NOTICE OF MEETING OF THE PLANNING AND ZONING COMMISSION

Notice is given that a **PUBLIC** meeting will be held before the Planning and Zoning Commission of the City of Hewitt on **Tuesday, December 1, 2020 at 6:00PM in the City Council Chambers at Hewitt City Hall, located at 200 Patriot Court, Hewitt, Texas** at which time the following subjects will be discussed:

NEIGHBORWORKS SUBDIVISION

RE: CITY OF HEWITT
RE-REVIEW OF THE FINAL PLAT FOR LOT 1, BLOCK 1, MIDWAY I.S.D.
ELEMENTARY NUMBER SEVEN ADDITION, RE-REVIEW DATE 11/29/2020.

C-01

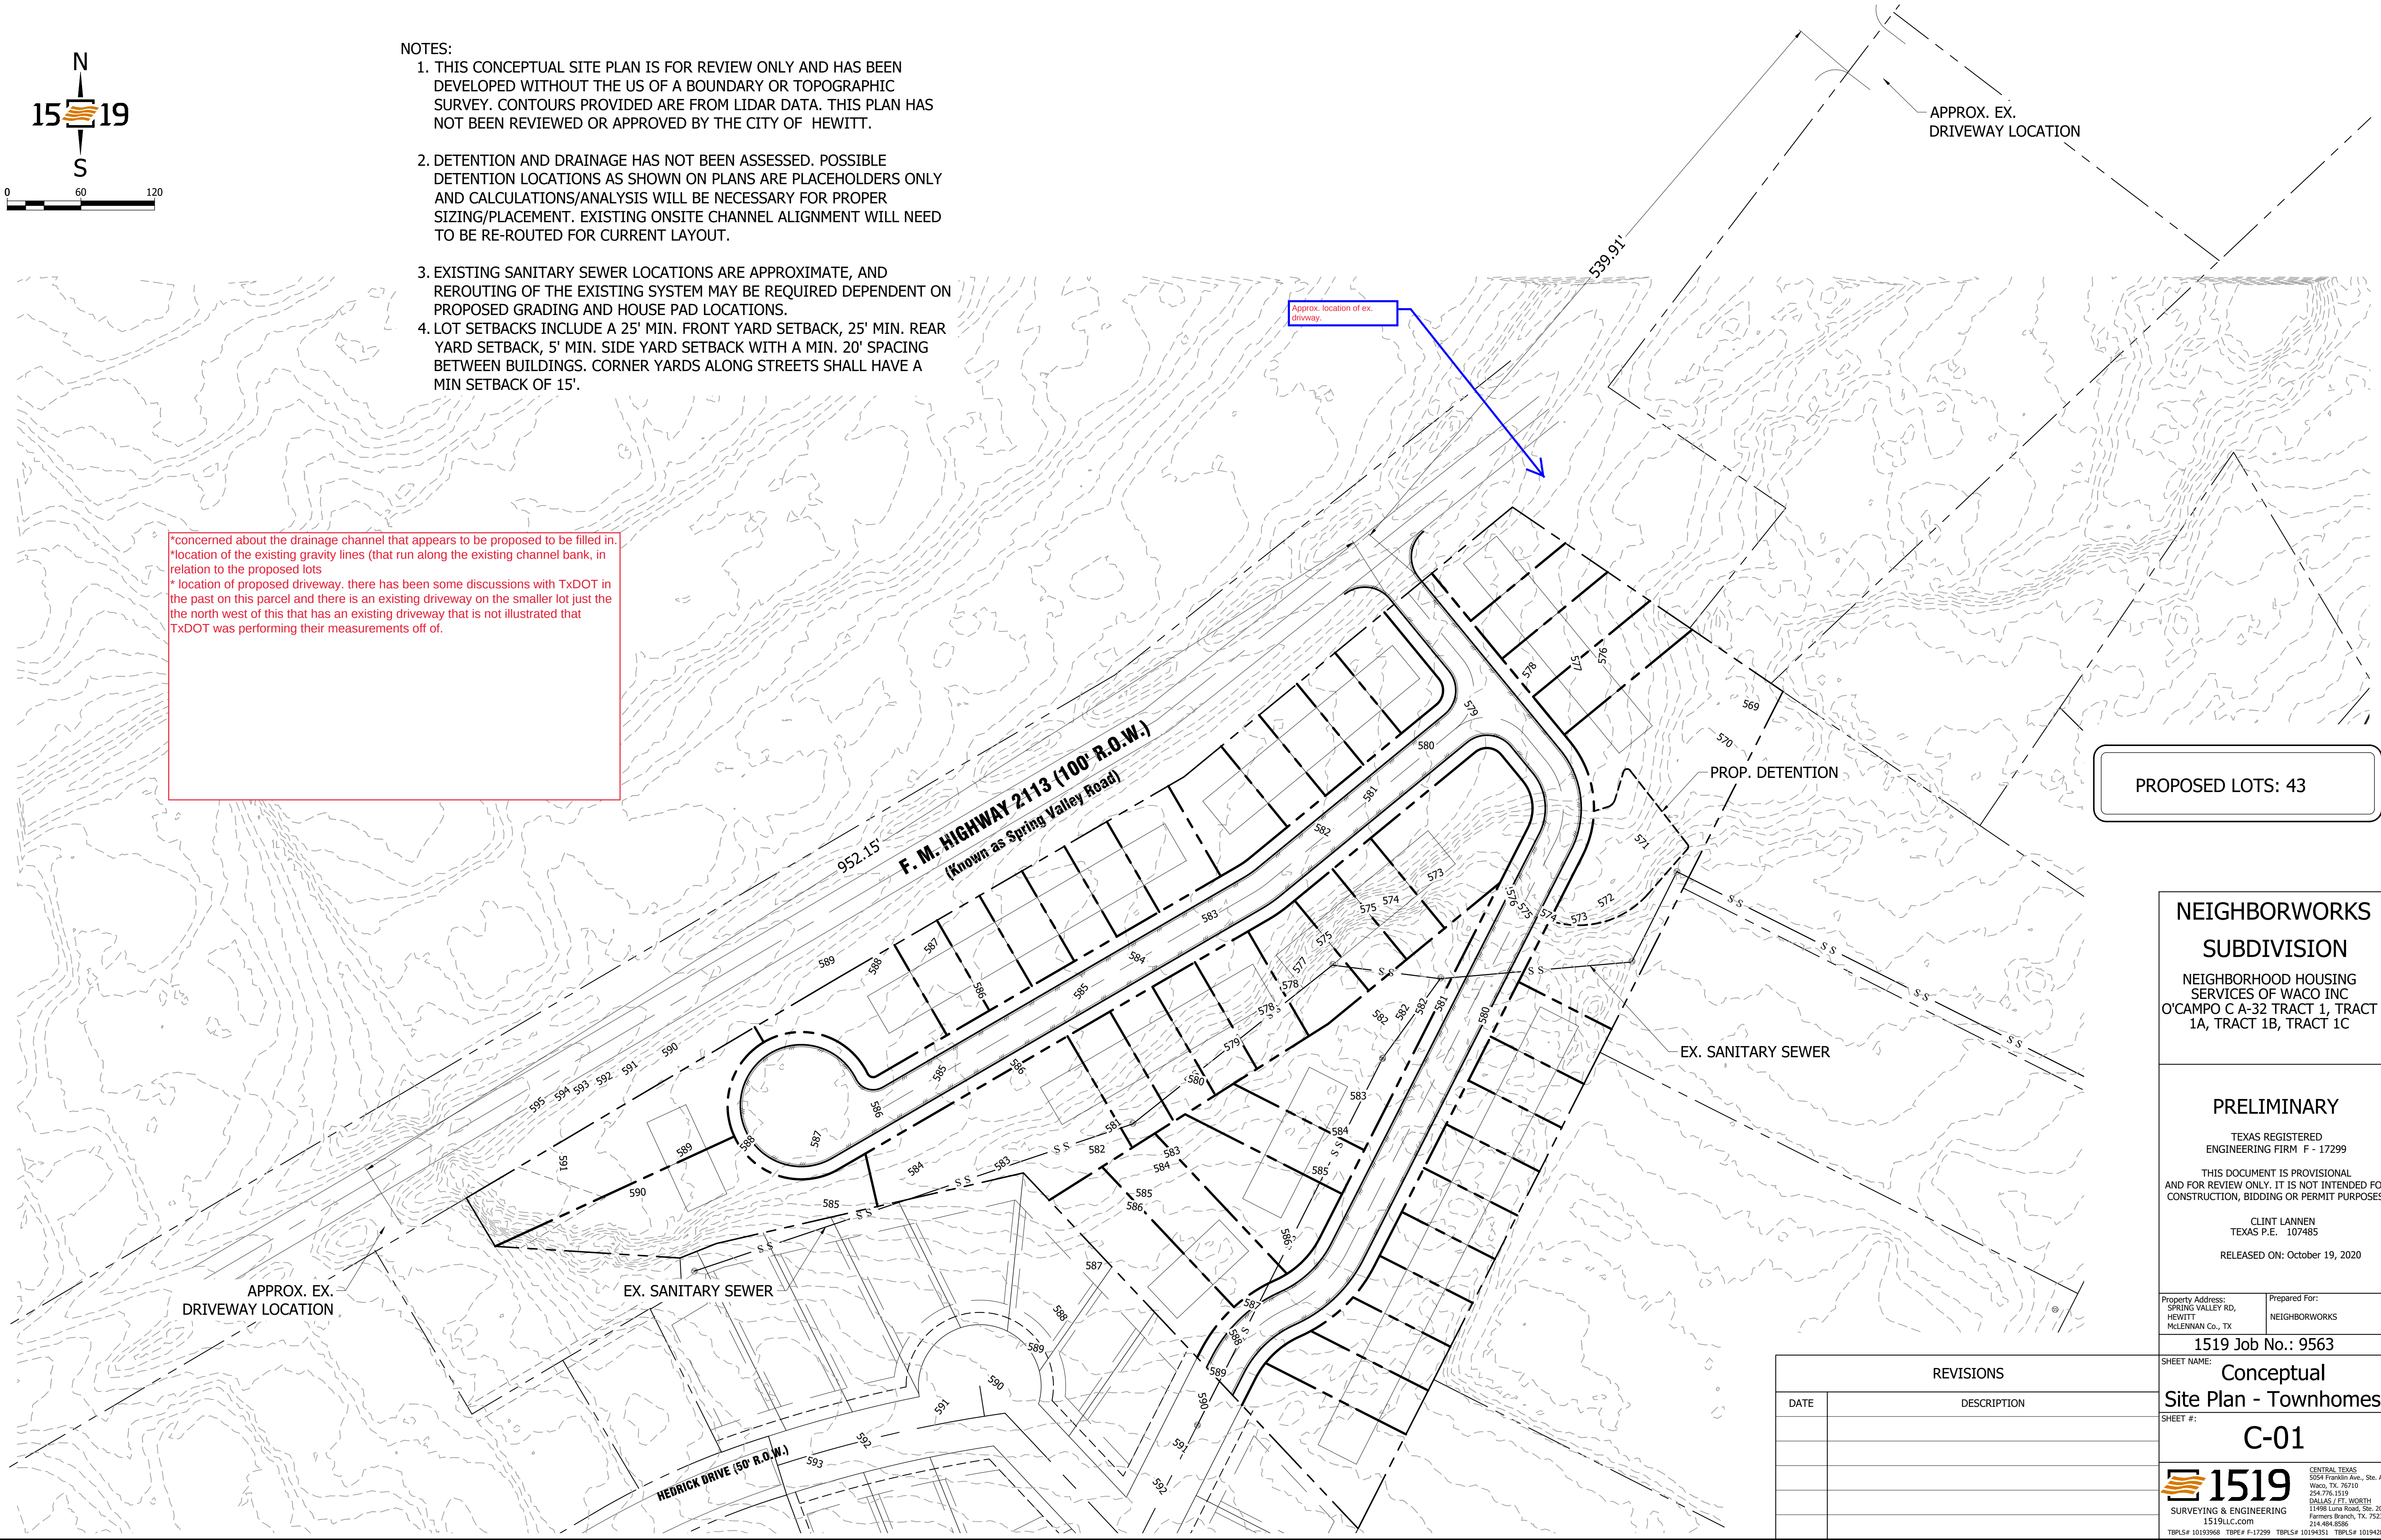
*concerned about the drainage channel that appears to be proposed to be filled in.
*location of the existing gravity lines (that run along the existing channel bank, in relation to the proposed lots
* location of proposed driveway. there has been some discussions with TxDOT in the past on this parcel and there is an existing driveway on the smaller lot just the the north west of this that has an existing driveway that is not illustrated that TxDOT was performing their measurements off of.
